TO: Kathy Bell, Senior Planner, City of Bellingham  
Steve Sundin, Senior Environmental Planner, City of Bellingham  
Kurt Nabbefeld, SEPA Responsible Official, City of Bellingham  
FROM: Janet Migaki, Bellingham Resident  
DATE: March 12, 2022  
RE: The Woods at Viewcrest, Project # SUB2022-0011

**From:** Barbara Murtaugh <Babs226@msn.com>  
**Sent:** Saturday, March 12, 2022 11:46 AM  
**To:** Bell, Kathy M.; Sundin, Steven C.; CC - Shared Department (ccmail@cob.org); MY - mayorsoffice@cob.org  
**Subject:** Jones Subdivision

**From:** Larry Horowitz <dakini1@comcast.net>  
**Sent:** Wednesday, March 23, 2022 12:38 PM  
**To:** Bell, Kathy M.  
**Cc:** Sundin, Steven C.  
**Subject:** Jones Plat/Subdivision  
**Attachments:** Shellfish Safety Map Mud Bay vs Chuckanut Bay.JPG; Mud Bay vs Chuckanut Bay.JPG

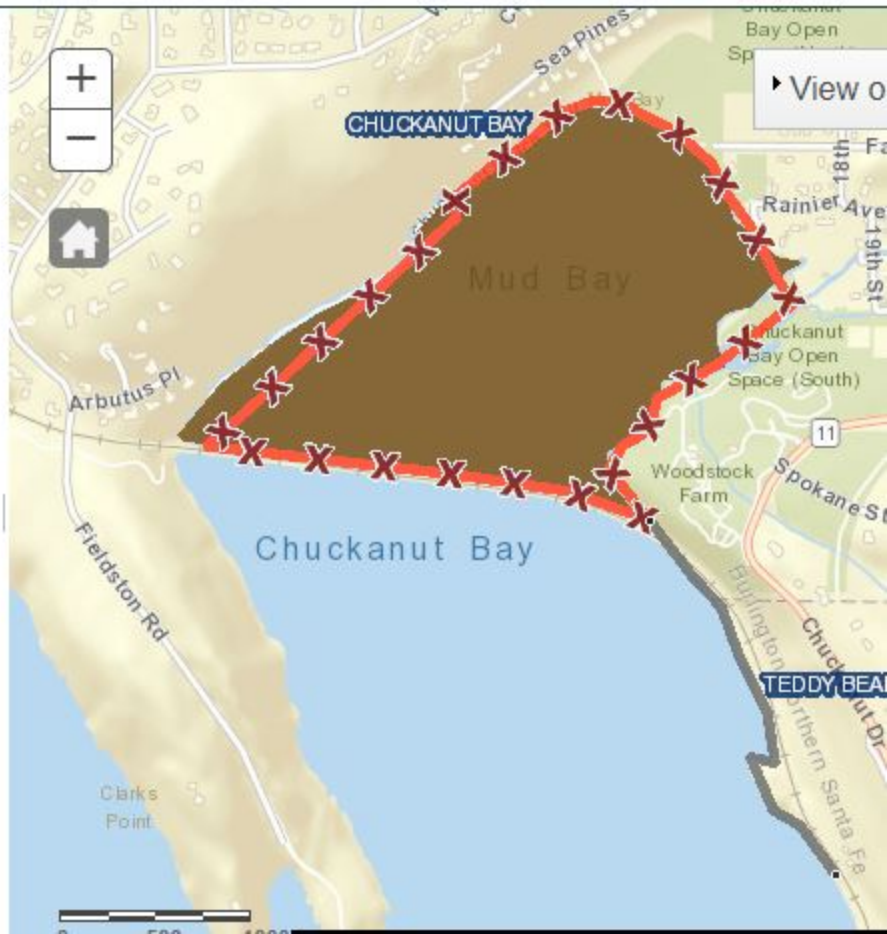
2) The experts in our group who have reviewed the Stormwater Management Report have found glaring weaknesses. Importantly, the applicant claims that stormwater runoff from TDA 2 is exempt from flow control requirements because Chuckanut Bay is considered a flow control exempt saltwater body. In reality, Mud Bay is distinct from Chuckanut Bay in many respects. Certainly, Mud Bay cannot be considered a free-flowing oceanic system. As evidenced by the WA State Dept of Health Shellfish Safety Map (attached), Mud Bay is not only separately named from Chuckanut Bay, but it exhibits completely unique characteristics. Note that the City's own CityIQ map (also attached) names Mud Bay separately from Chuckanut Bay.
